REMARKS

Claims 1-14, 16-22, 24-41 are rejected. In response to the office action dated July 11, 2007, Applicants amended claims 1, 21-22, 30-32, and 35-36. Claims 42-66 were added and claims 20, 23, 39-41 were canceled. Claims 1-19, 21-22, 24-38, and 42-66 are now pending in the application. Claims 1, 30, 31, 35, and 42 are independent claims. Applicants traverse these rejections and respectfully request reconsideration of the rejected claims in light of the above amendments and following remarks.

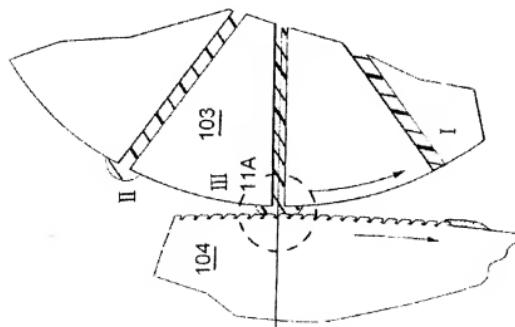
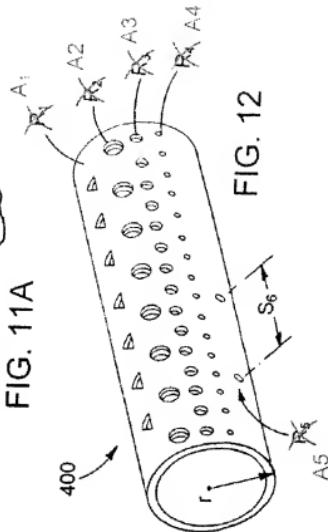
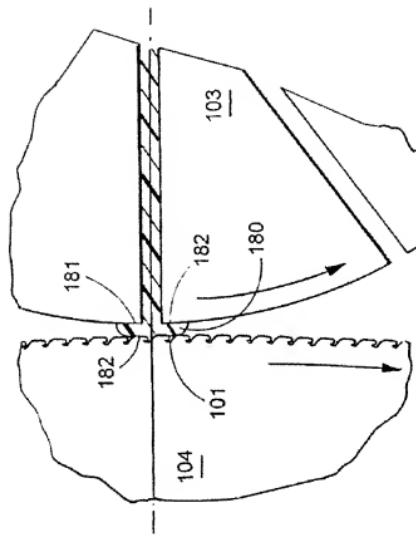
The drawings were objected to as failing to comply with 37 C.F.R. 1.84(p)(4) because reference characters "R₁, R₂, R₃, and R₄" have been used to designate rows of apertures in FIG. 12 and rows of resin in FIGS. 18 and 20. FIG. 12 has been amended to replace reference

characters "R₁, R₂, R₃, R₄ and R₅" with the following reference characters: "A₁, A₂, A₃, A₄ and A₅", and the corresponding paragraphs, [0077] and [0078], of the specification have been amended accordingly.

FIG. 16

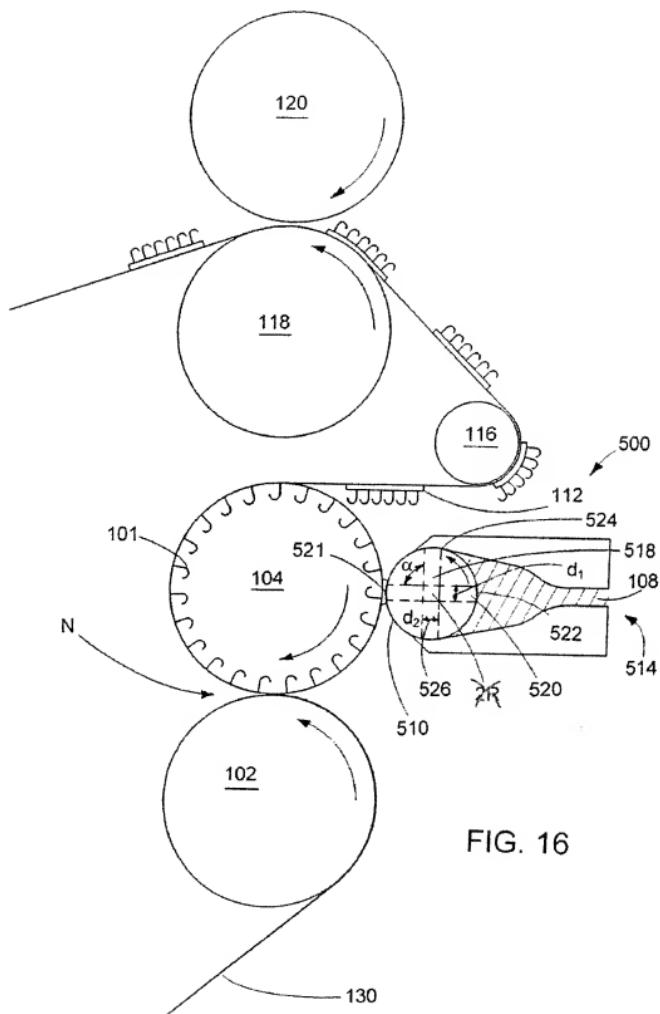
FIG. 16 was objected to because reference character "2R" is shown but not mentioned in the detail description. FIG. 16 has been amended to remove reference character "2R".
